**PLANNING COMMISSION STAFF REPORT
ADMINISTRATIVE ITEM**

**ARLINGTON PARK
Planned Development PLNSUB2013-00049
1075 East 800 South
May 8, 2013**

Site Plan

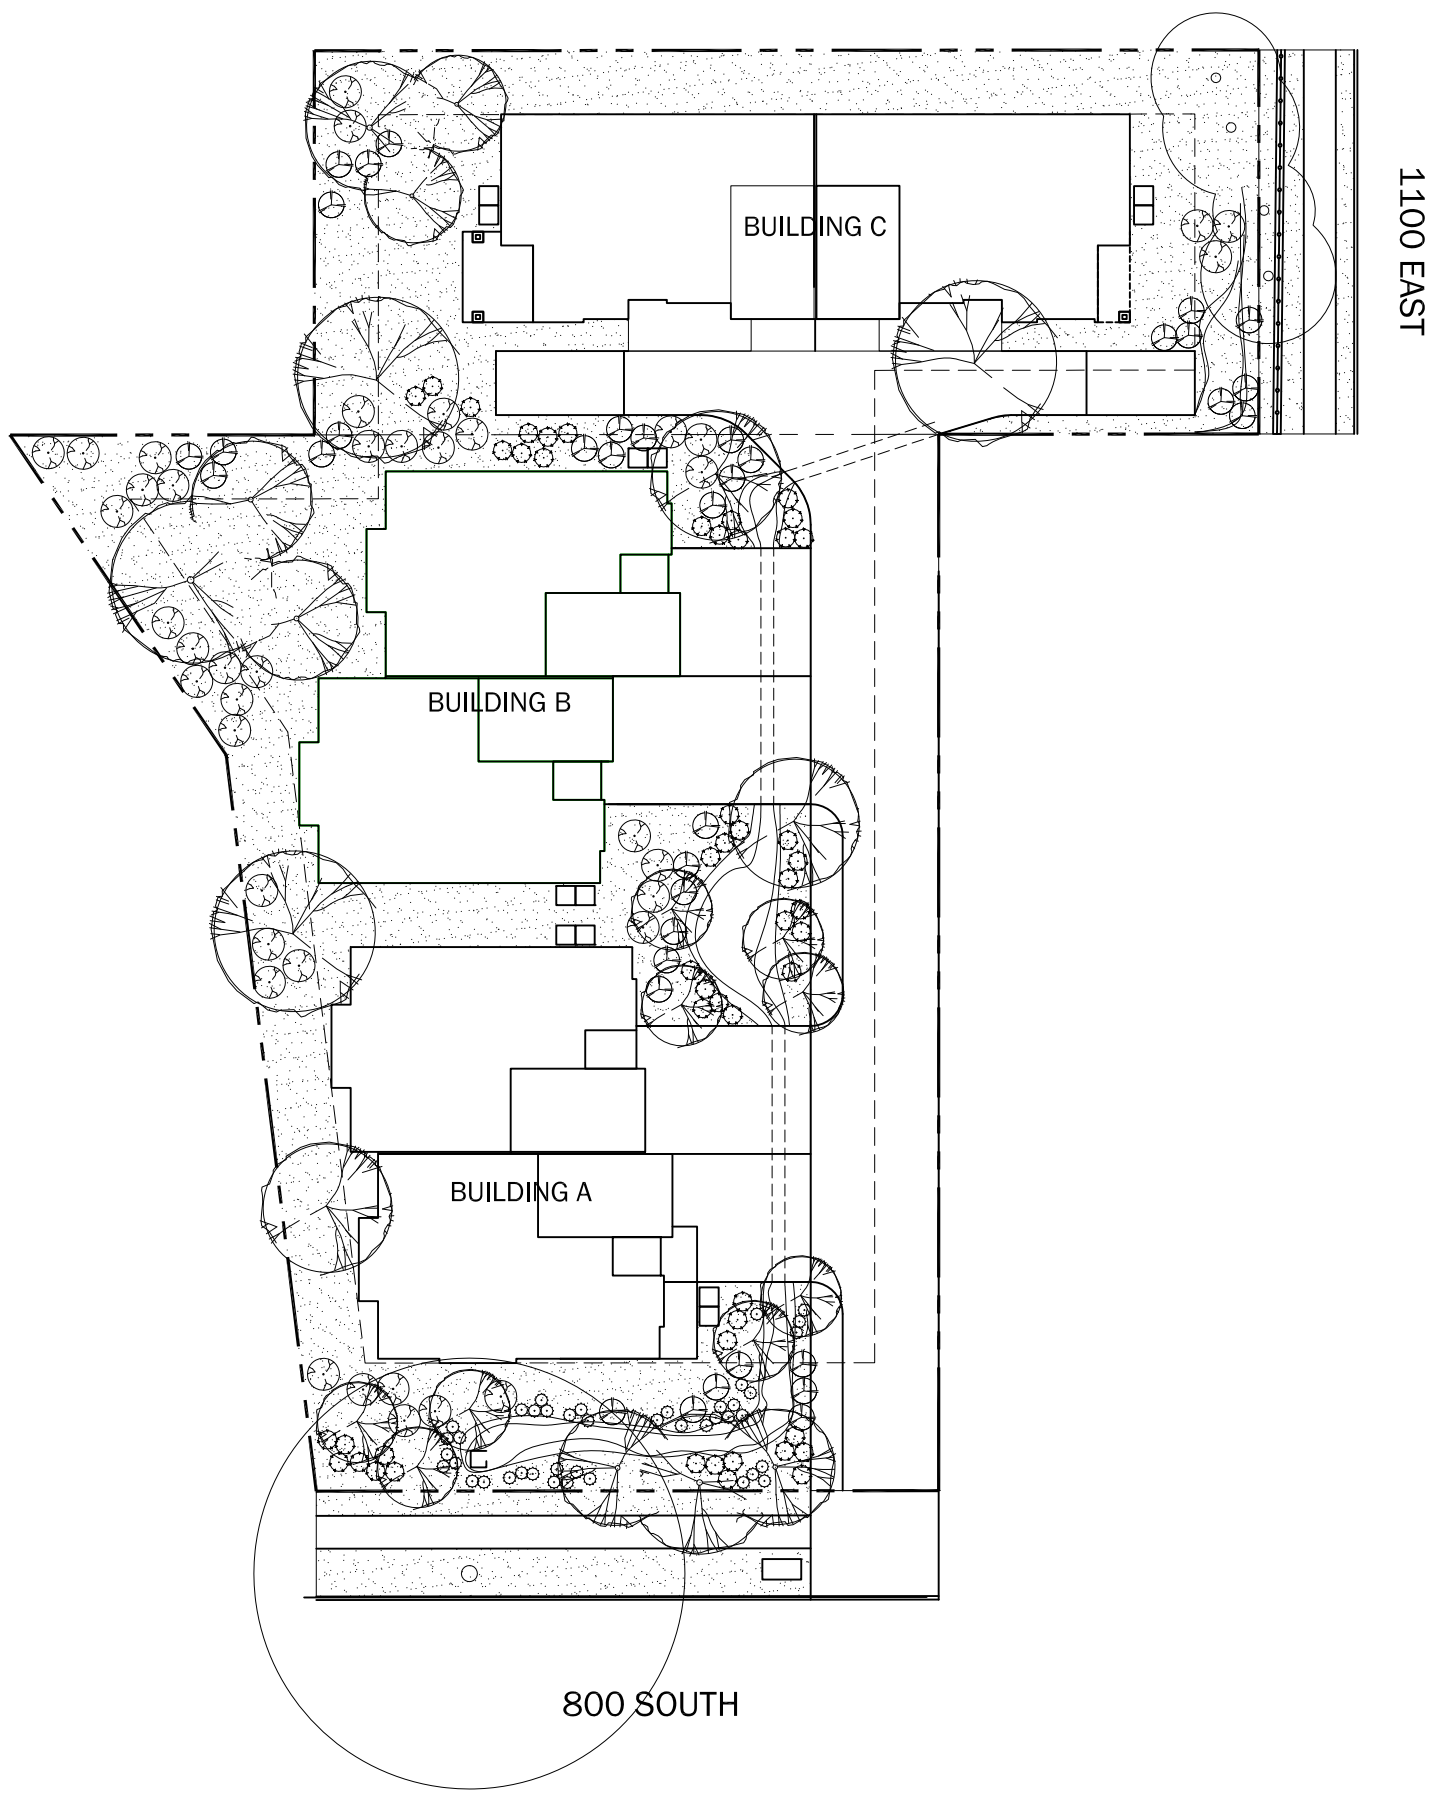
- 2) A rear yard setback is required along the north property line unless an alternate setback is stipulated by the planned development process and in keeping with 21A.55.100.

- 9) Section 21A.44.020.F.7.a, requires driveways to be located at least 6 feet from the property line.
- 10) Please document the surface coverage of all principal and accessory buildings on the plans (not to exceed 45% of the lot area).

- 11) Show existing and proposed public way improvements such as sidewalks, lights, trees, drive approaches, fire hydrants, etc., for both street frontages on the site plan.

- 14) A new legal description and parcel number are required and property lines matching the new legal description shall be dimensioned on the site plan.

Two stalls per units or 12 stalls are required. The site plan shows parking in front of the single stall garages, and some of the stalls shown on the Permeable paver stall locations are not accessible per city standards. The stalls for unit "C" do not have adequate turn around maneuvering area to enter the public road way in a forward manner.

BUILDING: A

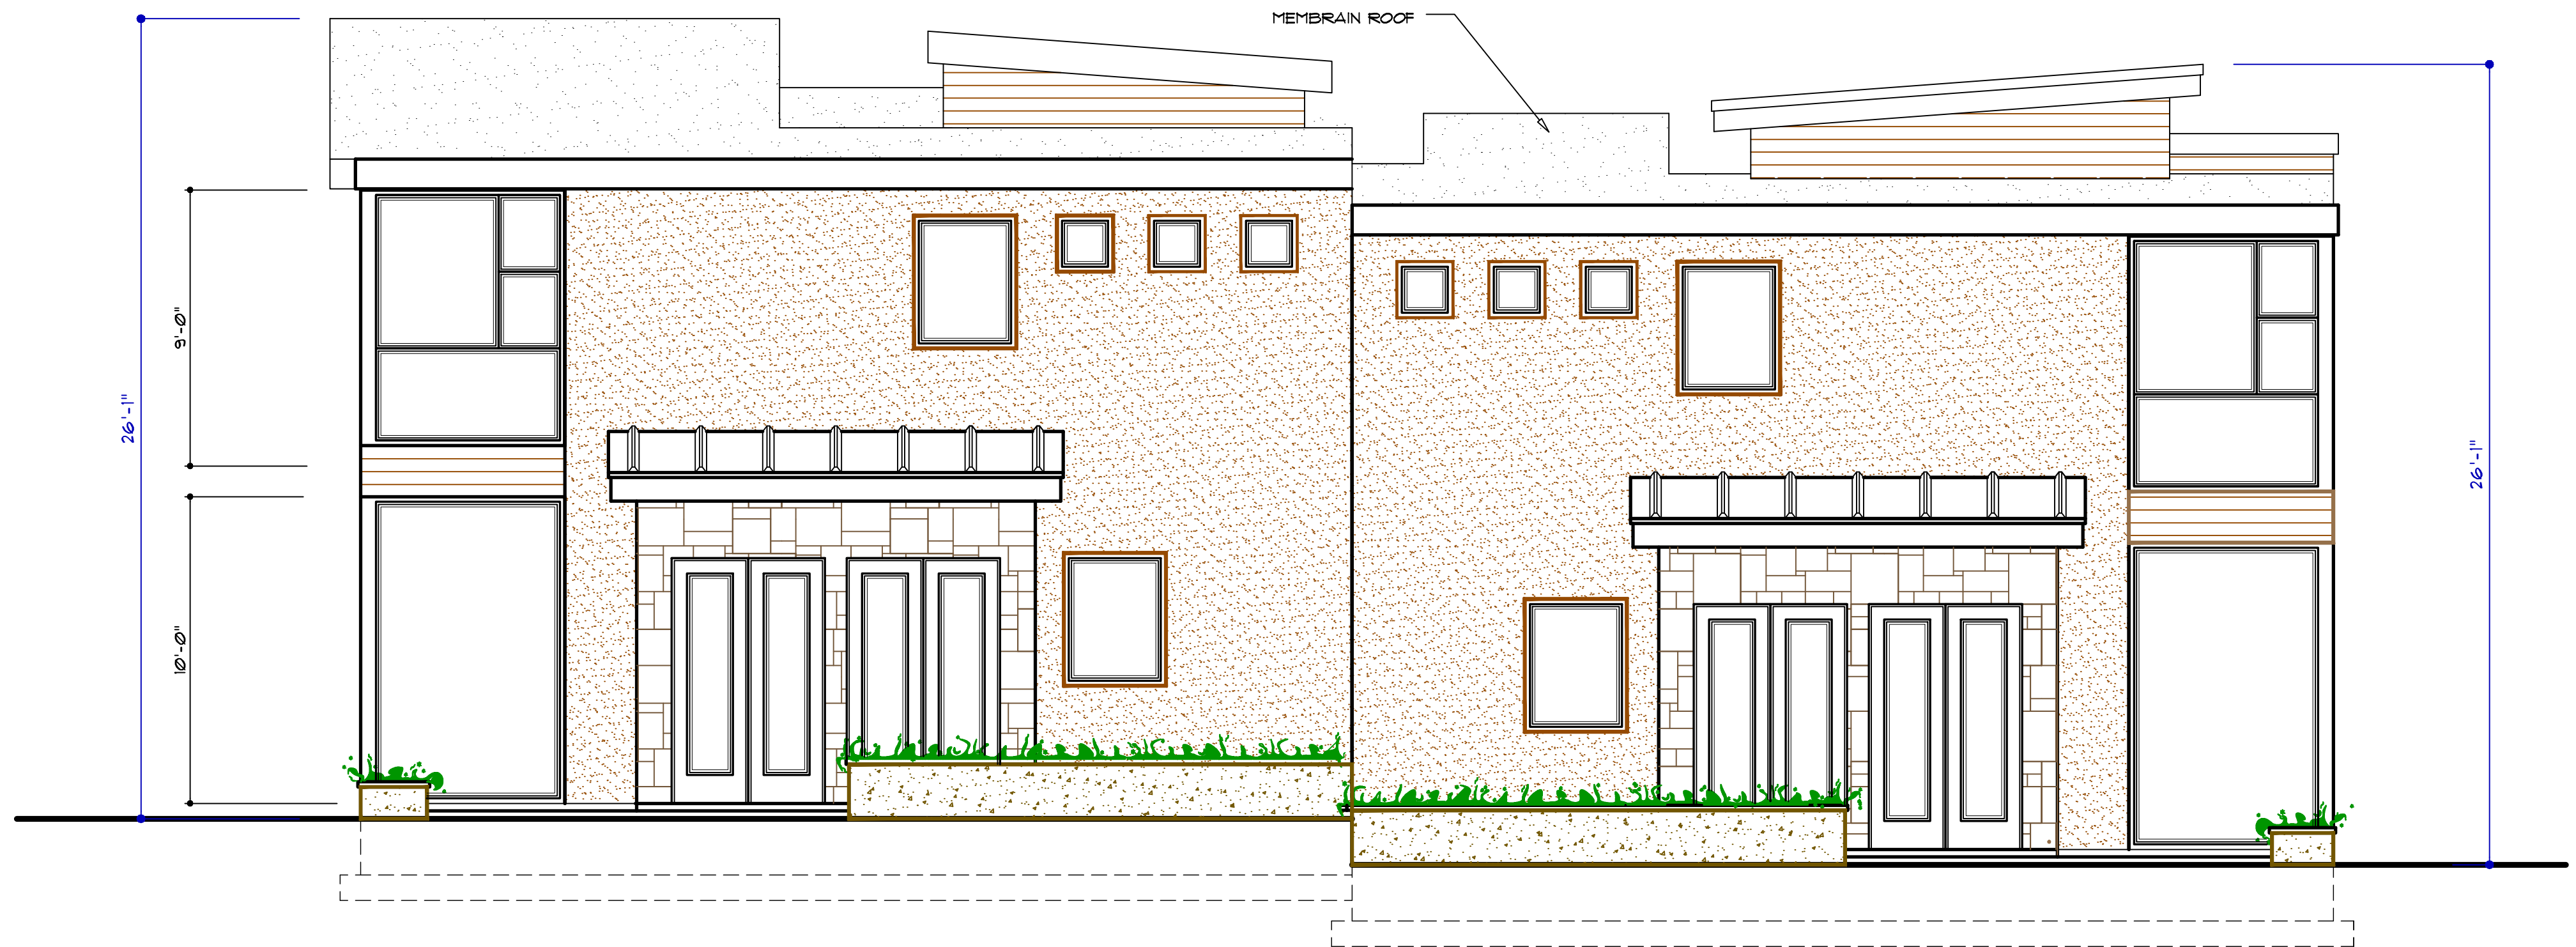
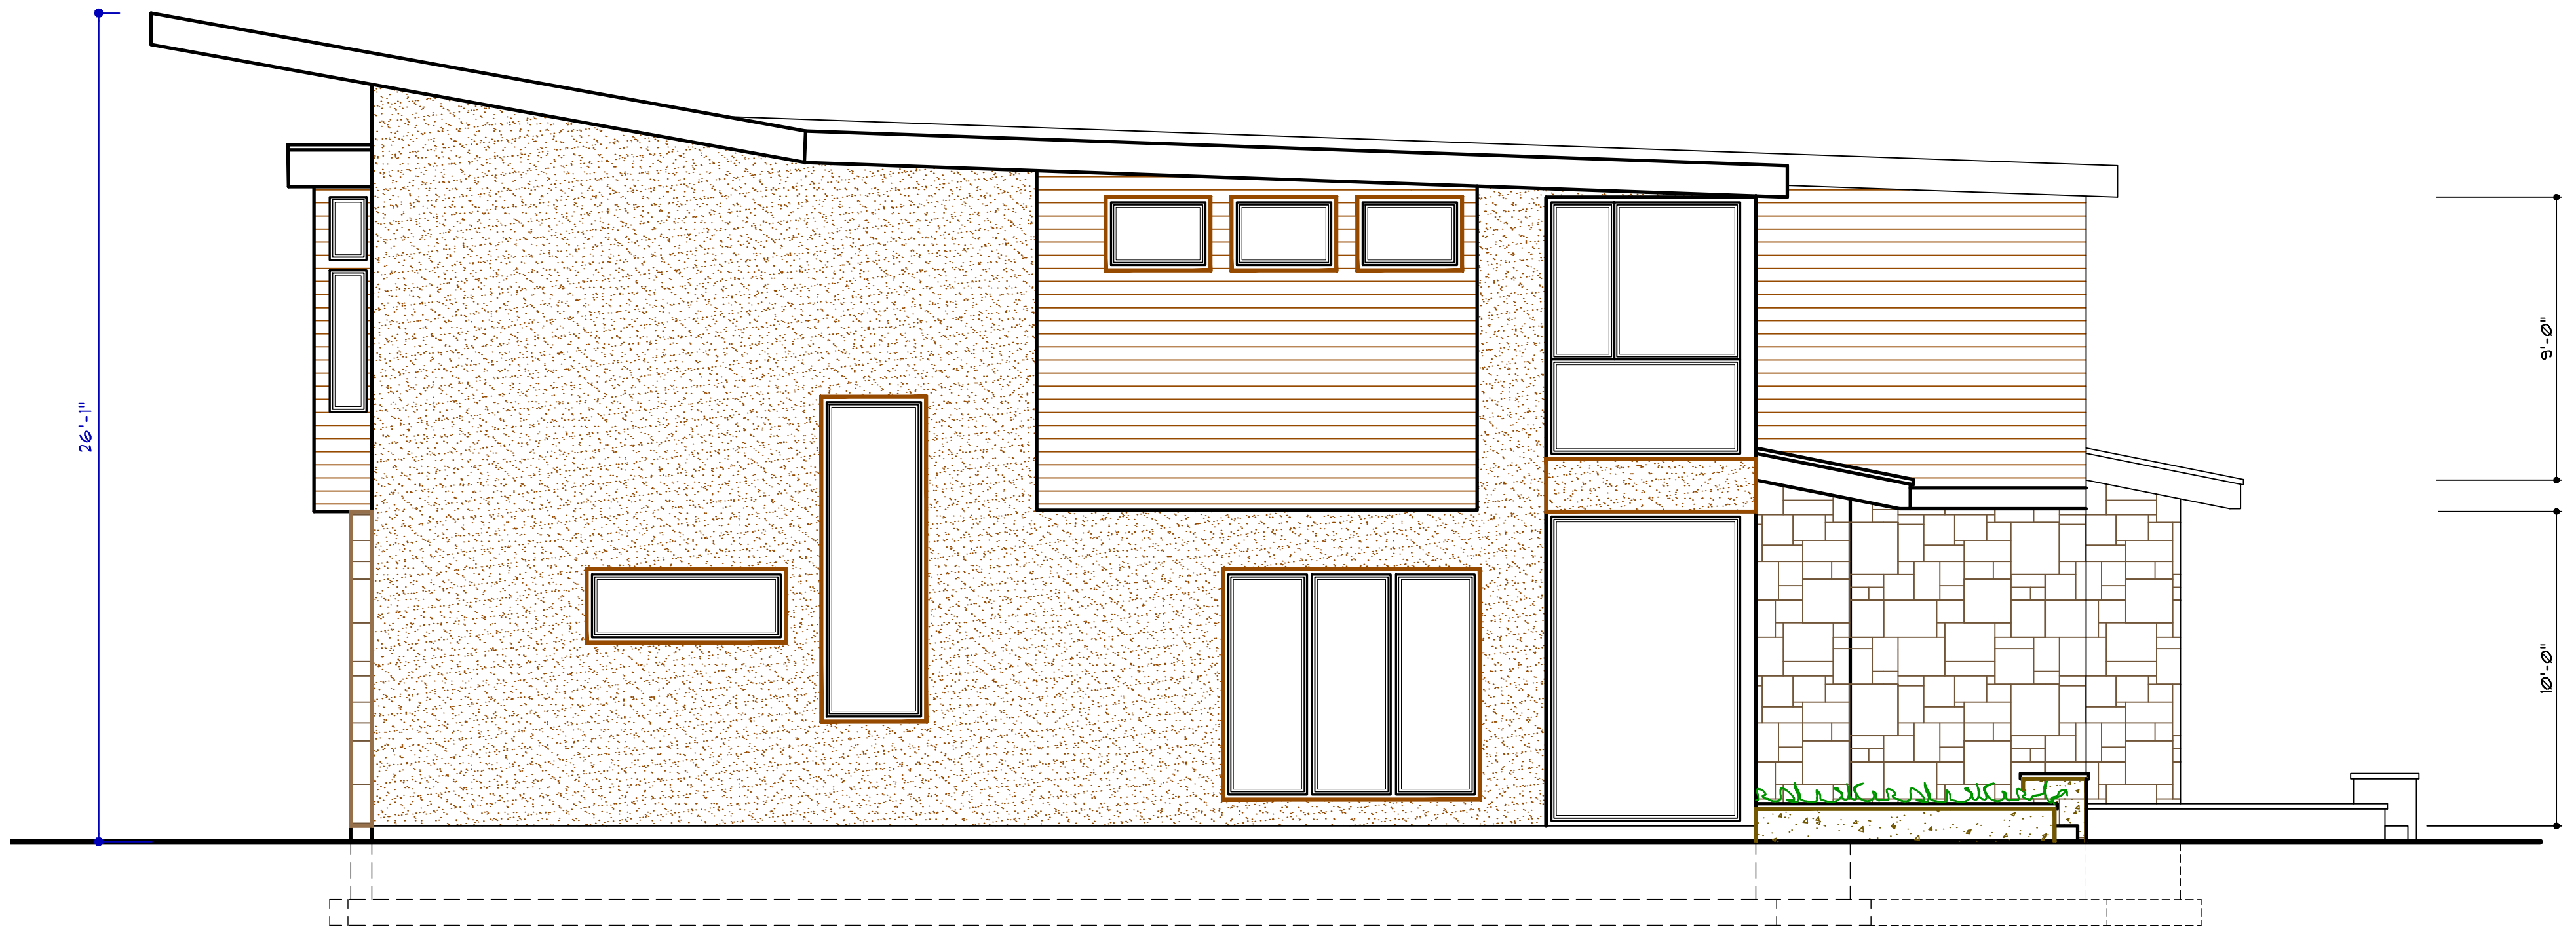
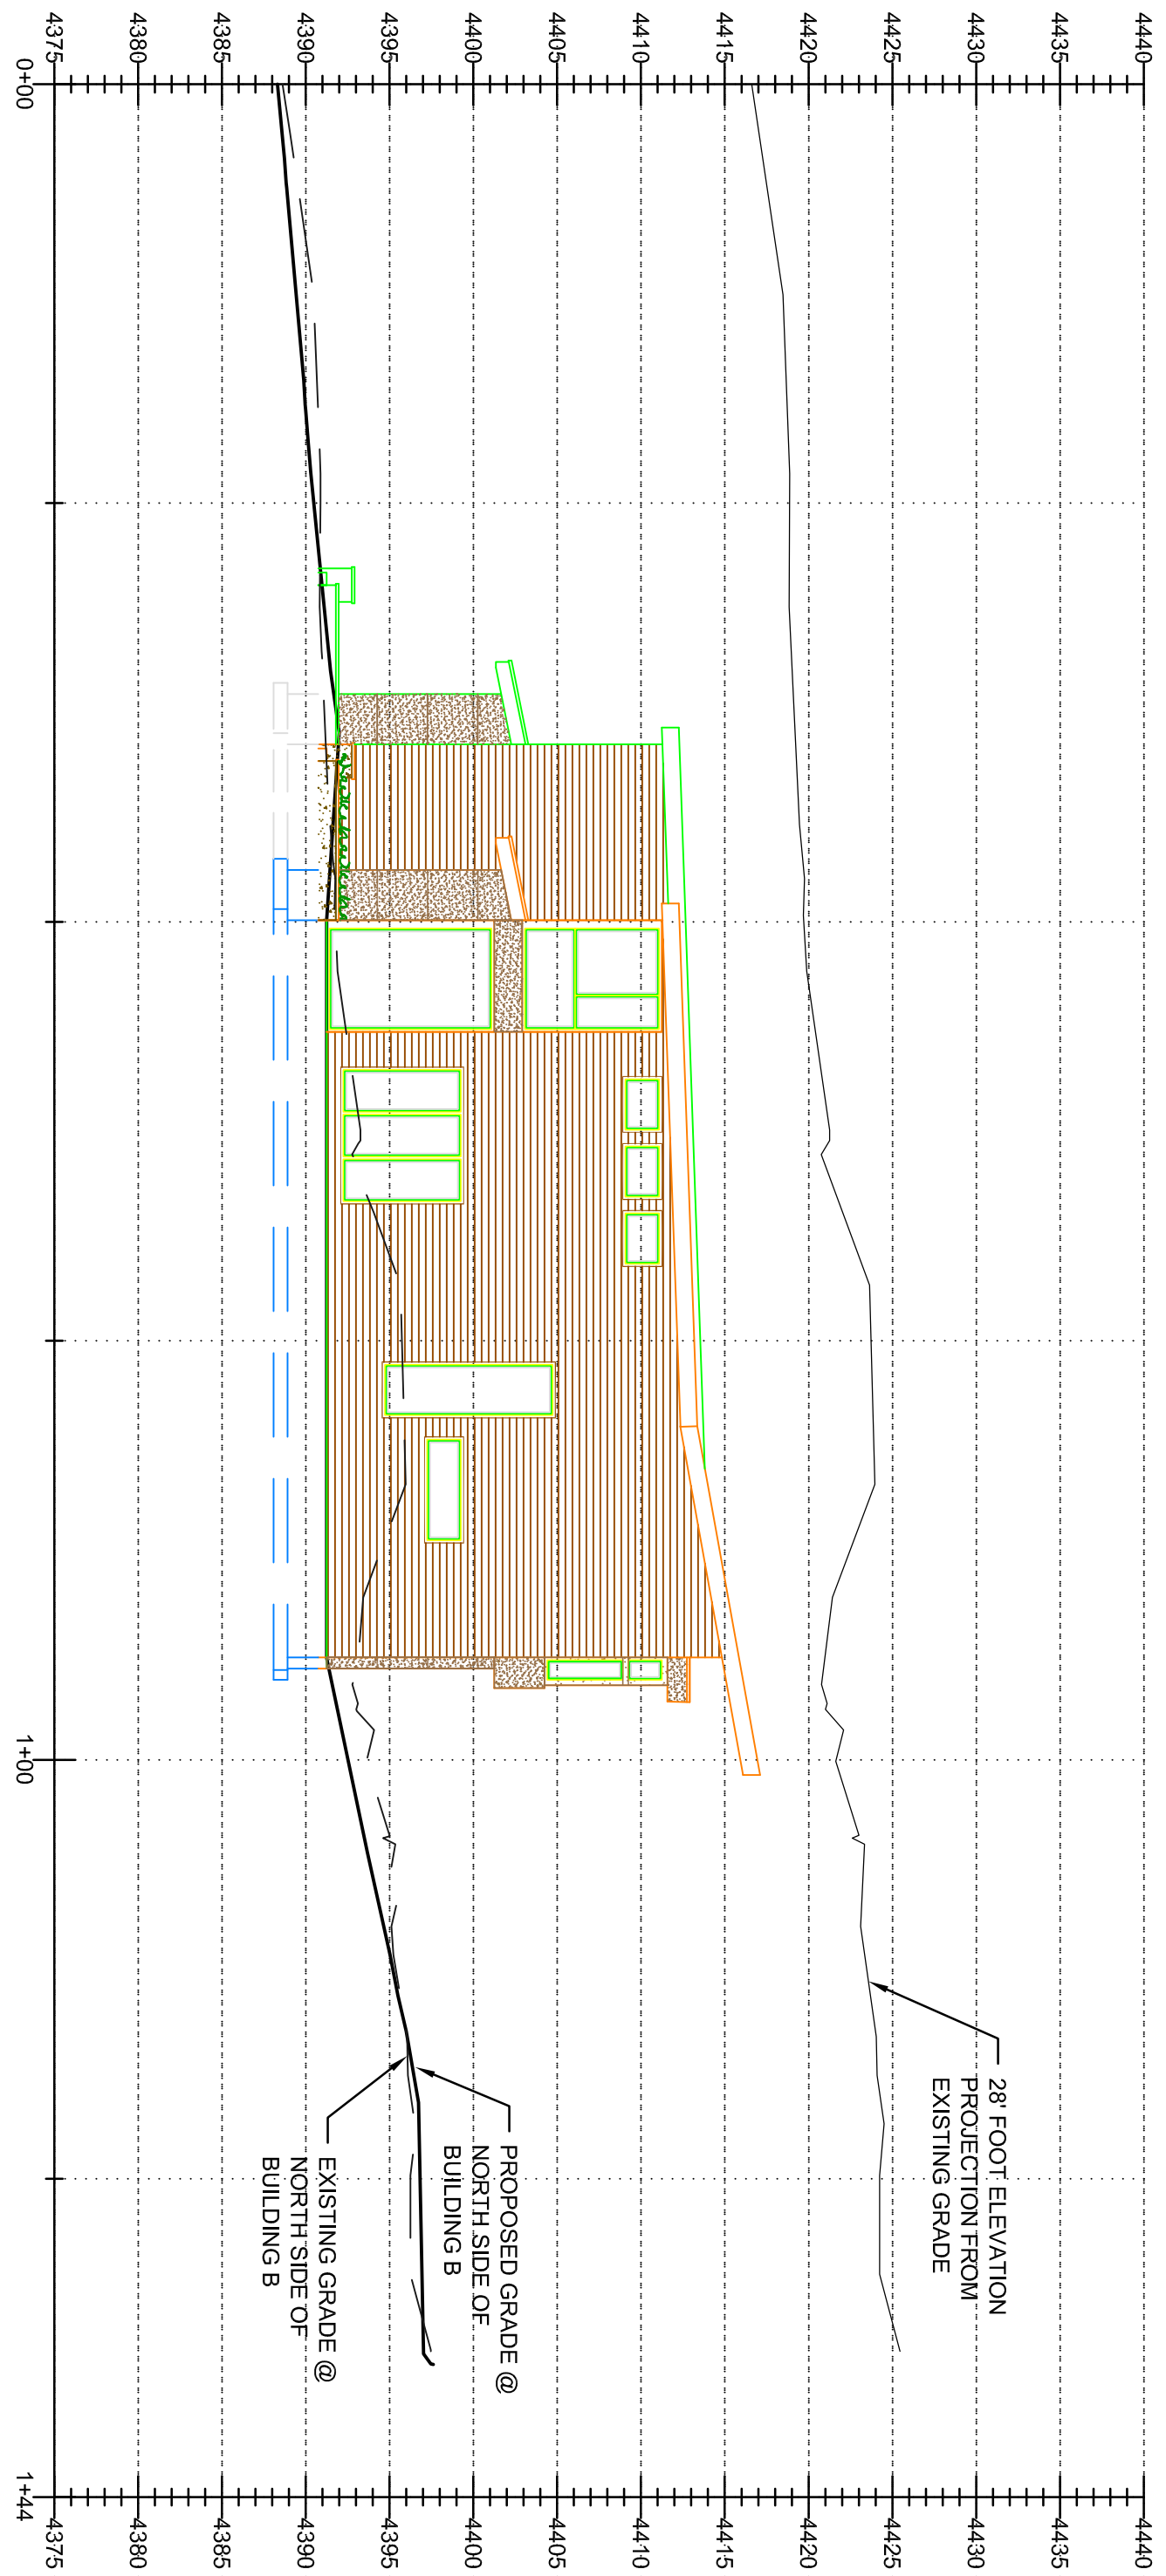
- 1) The structures exceed the maximum 28 feet height requirement of the R-2 zone for pitched roofs and exceed the maximum 20 feet flat roof height requirement. As per 21A.55.030, additional building height in the R-2 zone may not be approved by the planning commission through the planned development process. Increased building height may be approved as a special exception as per 21A.52, and if the proposed building height is in keeping with the development pattern on the block face.

- 4) The covered porches for buildings A and C are not permitted front yard encroachments as per Table 21A.36.020.B.
- 5) For clarity, please identify elevations for all buildings as north, south, east and west instead of front, rear, left and right and show that buildings A and C meet the front façade controls as per 21A.24.010.I, or comply with landscaping and setback requirements for side entry buildings as per 21A.24.010.H.
